MEMORANDUM

SUBJECT: 2023 Road Program Tree Evaluation

2023 ROAD IMPROVEMENT

STREET	REMOVED DUE TO CONSTRUCTION	REMOVED DUE TO HEALTH	TREE PROTECTION PLATE	TREE TO REMAIN
Linden Avenue	8	1	7	17
Cedar Avenue	0	2	4	22
Wayne Avenue	8	2	0	9
West Summit Avenue	3	4	0	12
Heritage Road	3	2	1	32
Lafayette Avenue	5	0	1	1

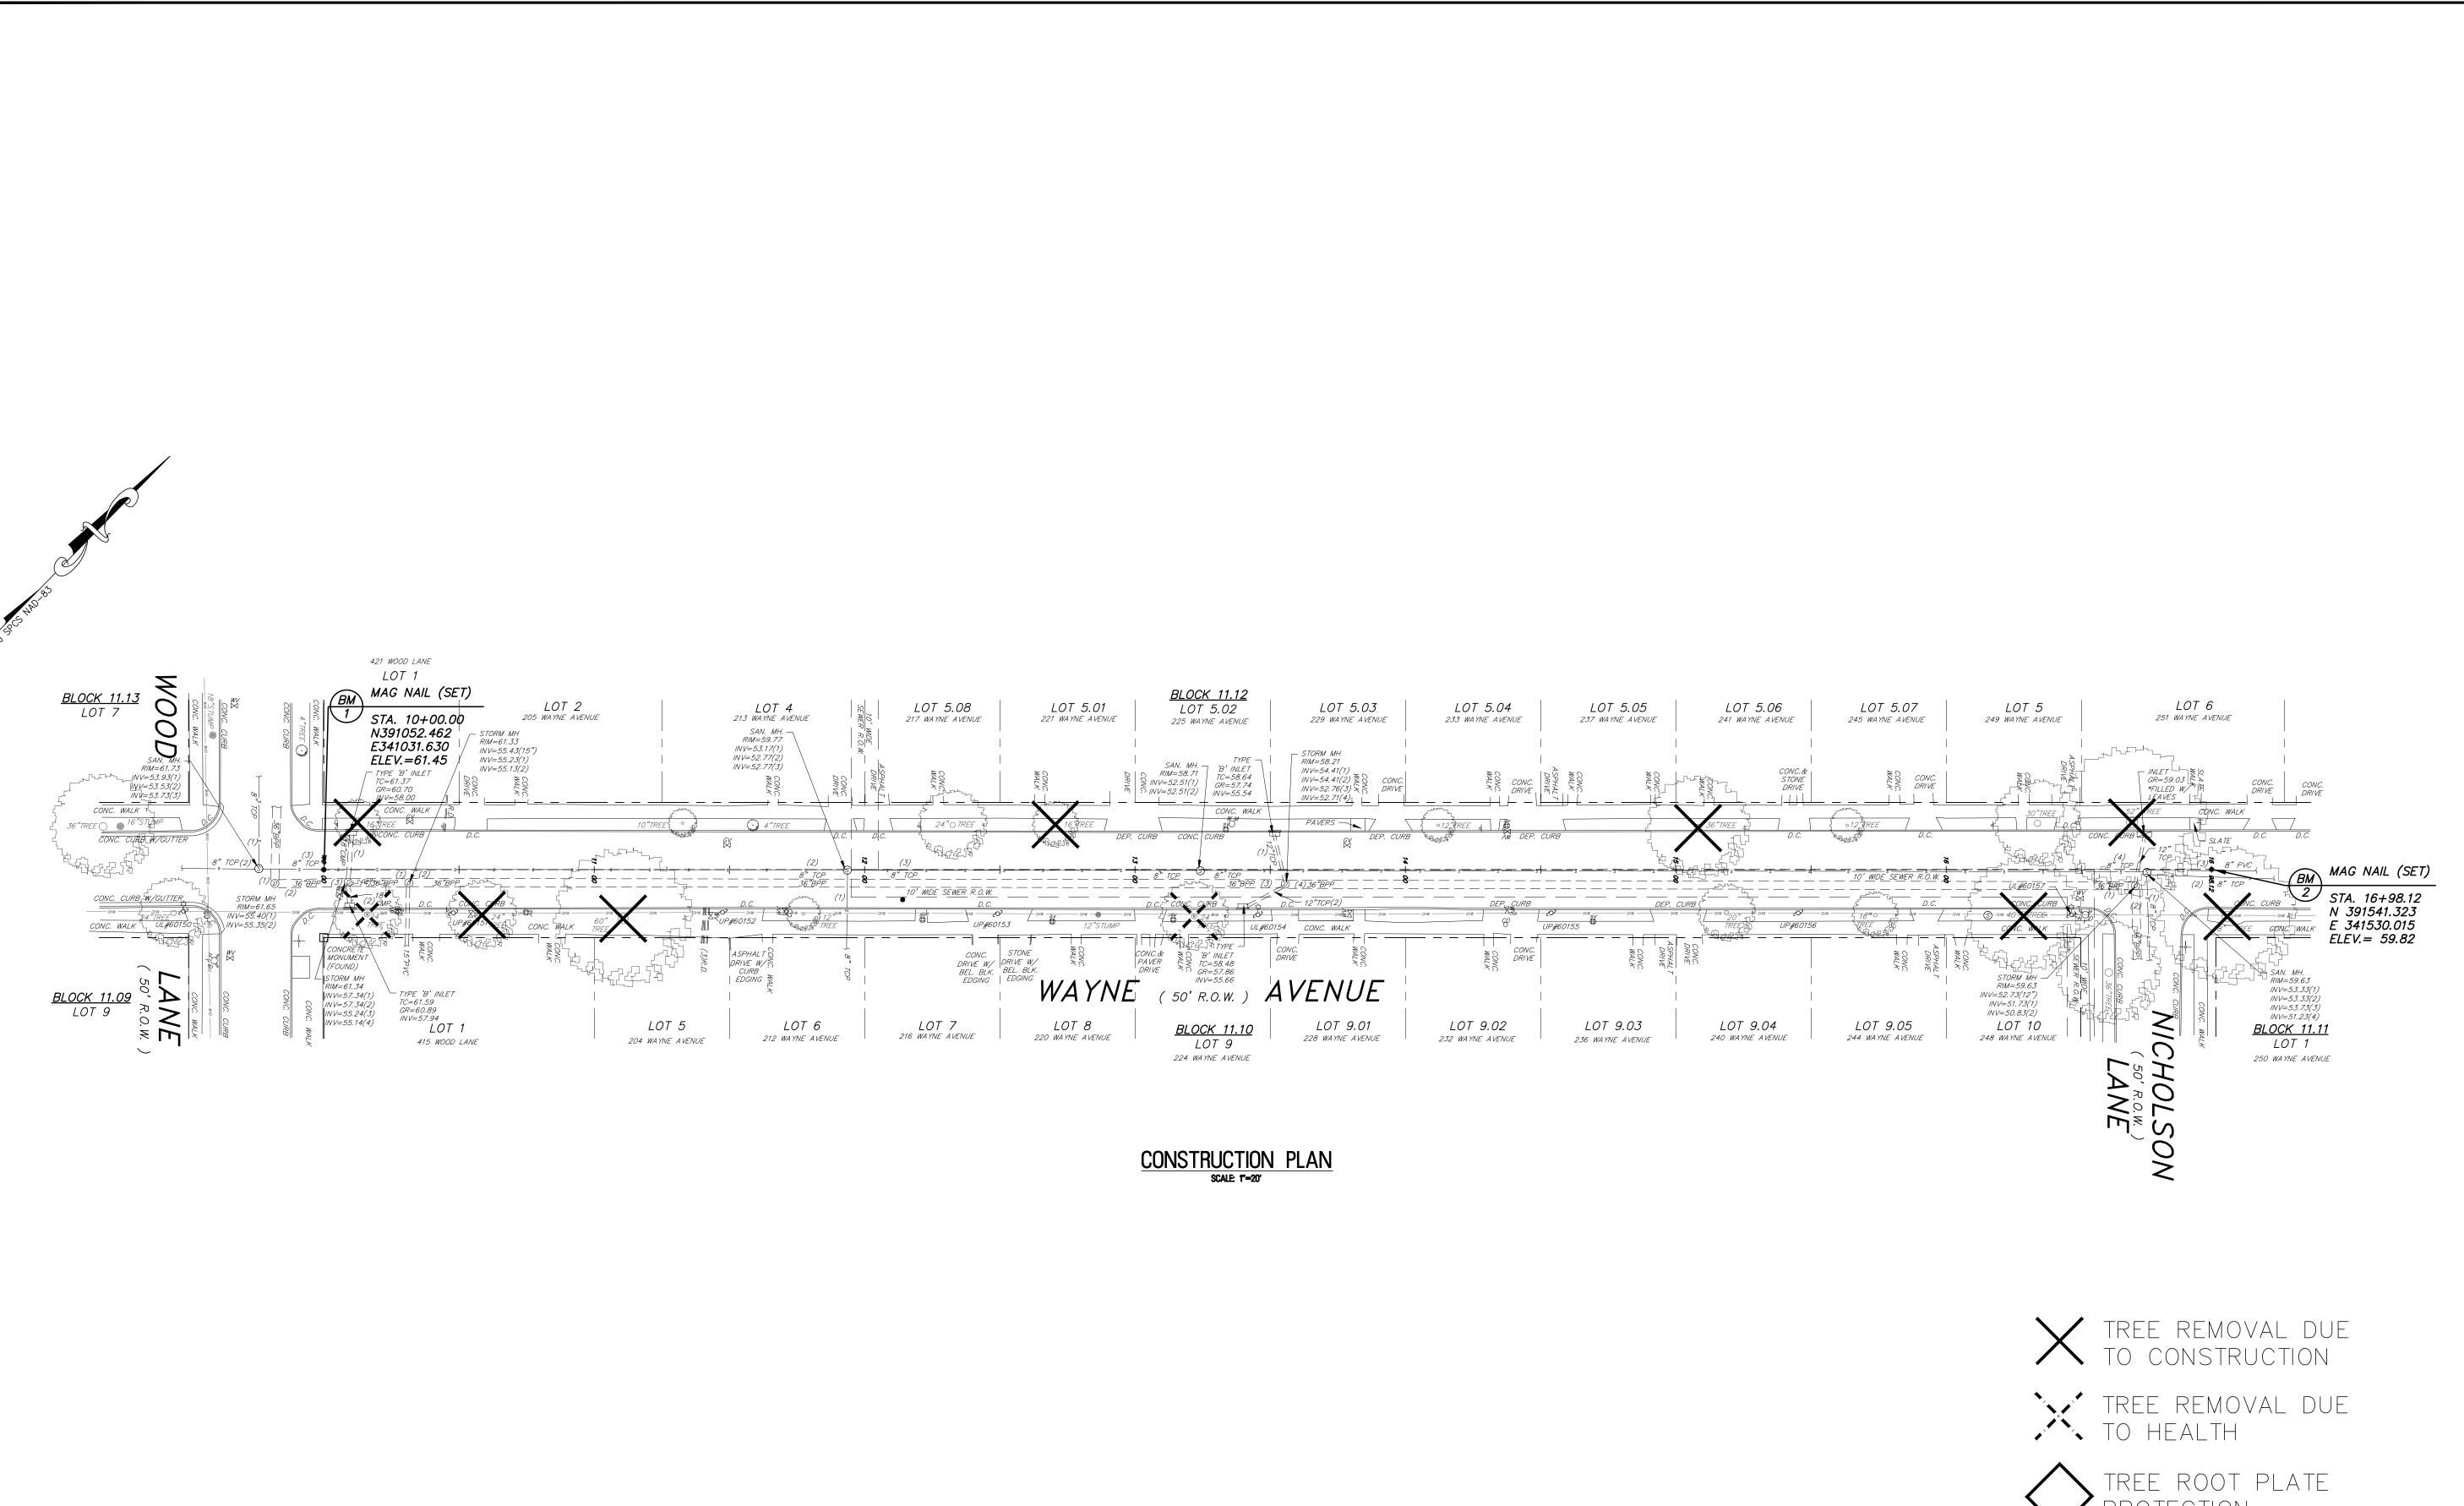
17 Lafayette Avenue 40" Red Oak (F1) is in good condition and overhangs part Tree to be removed due to construction

of the curb and road

19 Layafette Avenue 24" tree with roots Tree to be removed overhanging the curb and due to construction

pushing the curb out

WAYNE AVENUE ONSTRUCTION PL

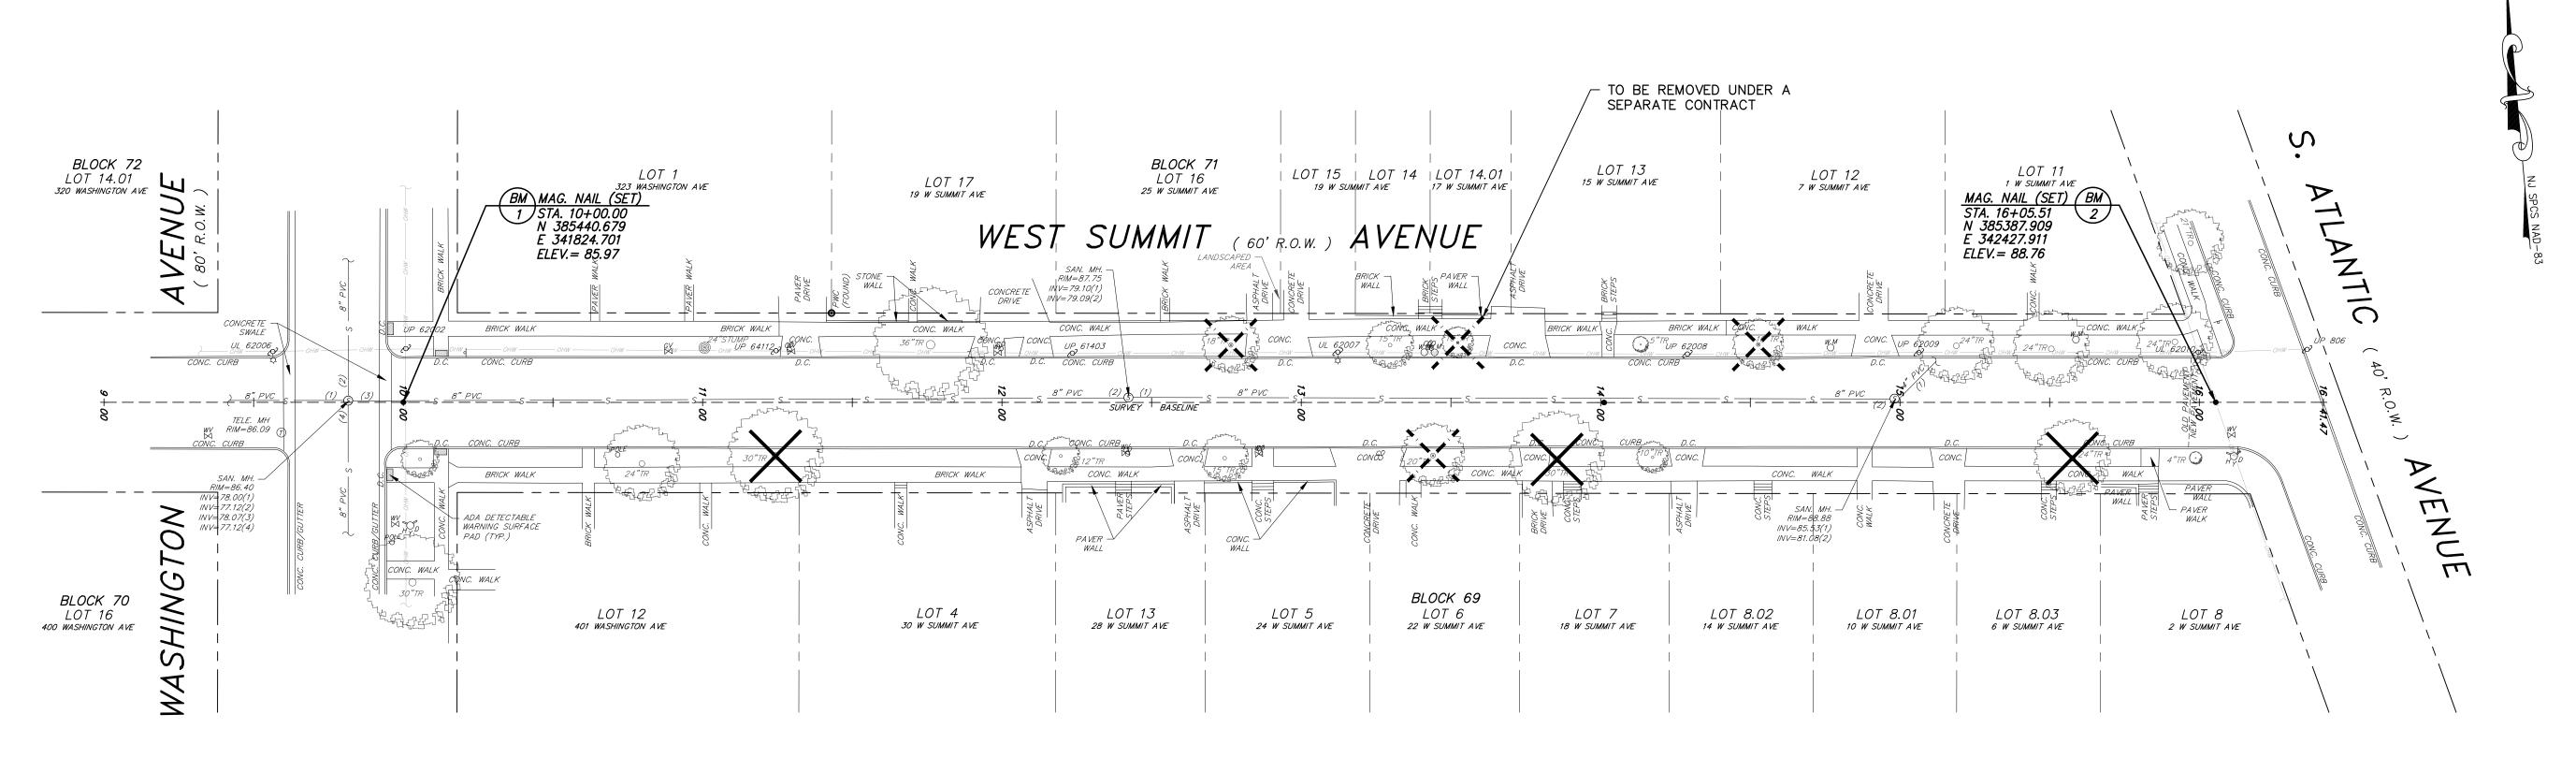
250 Wayne Avenue	48" tree with roots overhanging the curb and pushing the curb out	Tree to be removed due to construction
248 Wayne Avenue	36" Pin Oak (F1) is in good condition with roots overhanging the curb and road	Tree to be removed due to construction
224 Wayne Avenue	18" Red Oak (F1) is in poor condition	Tree to be removed due to poor condition
204 Wayne Avenue	60" Willow Oak (F1) is in good condition with roots overhanging the curb and road	Tree to be removed due to construction
415 Wood Lane	22" Pin Oak (F2) is in poor condition with roots overhanging on the curb	Tree to be removed due to poor condition and construction
415 Wood Lane	22" Red Oak (F3) is girdling itself and is in poor condition	Tree to be removed due to poor condition
421 Wood Lane	16" Sugar Maple (S1) might interfere with construction if storm drain needs to be replaced	Tree to be removed due to construction

221 Wayne Avenue	16" Red Maple (F1) is in good condition slightly pushing the curb out	Tree to be removed due to construction
241 Wayne Avenue	36" London Plane (F1) is in good condition with roots overhanging the curb	Tree to be removed due to construction
251 Wayne Avenue	52" Pin Oak (F1) might interfere with construction if storm drain needs to be replaced	Tree to be removed due to construction
709 Cedar Avenue	30" tree with roots against curb	Tree root protection plate to be installed
745 Cedar Avenue	30" Red Maple (F1) is in poor condition	Tree to be removed due to poor condition
704 Cedar Avenue	36" Oak (F1) is in poor condition	Tree to be removed due to poor condition
704 Cedar Avenue	36" tree with roots overhanging the curb and pushing the curb out	Tree root protection plate to be installed
708 Cedar Avenue	36" tree with roots overhanging the curb and pushing the curb out	Tree root protection plate to be installed
